Cub Crafters, Inc. Considers Compliance Mandatory

SUBJECT: UN-COMMANDED FLAP RETRACTION

MODELS AFFECTED: CC11-100 S/N00002 thru S/N00031

Figure 1

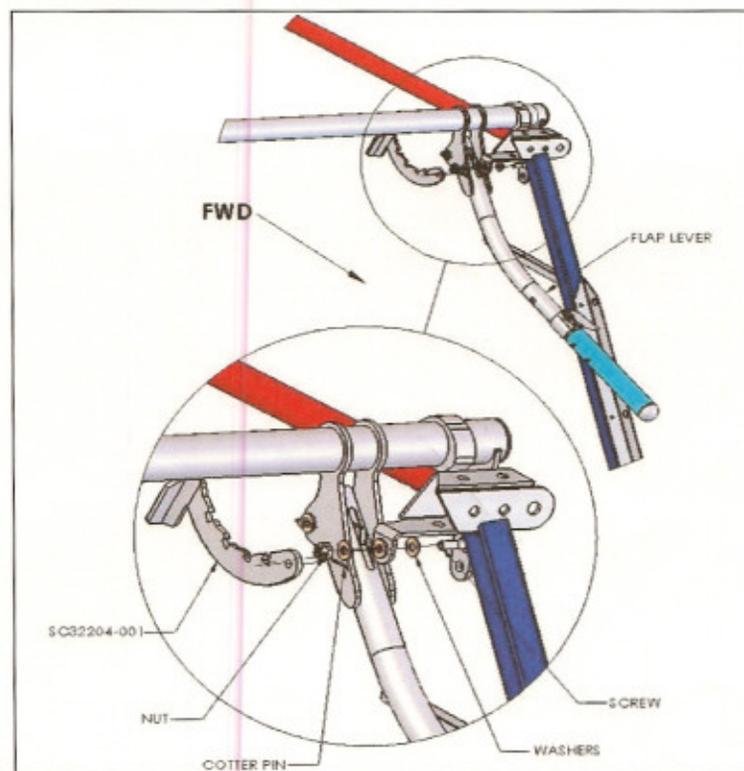
PURPOSE: THE FLAP LOCKING MECHANISM HAS THE POSSIBILITY OF DISENGAGING CAUSING UN-COMMANDED FLAP RETRACTION.

Remove old SC32204-001 part and replace with SC32204-001 revision F.

1. Remove existing SC32204-001 by removing hardware as shown in Figure 1. Retain hardware and discard SC32204-001 and cotter pin.
2. Rotate flap lever arm fore and aft while applying pressure inboard or outboard to center and align flap cross bar with fuselage centerline as necessary.
3. Install SC32204-001 Revision F using same hardware and new cotter pin (AN380-2-2). SC32204-001 should be centered thru flap lever slot (see Figure 2). Additional washers (AN960-10 or AN960-10L) may be used to shim SC32204-001 to achieve center position. Do not use more than 4 washers per side to shim.
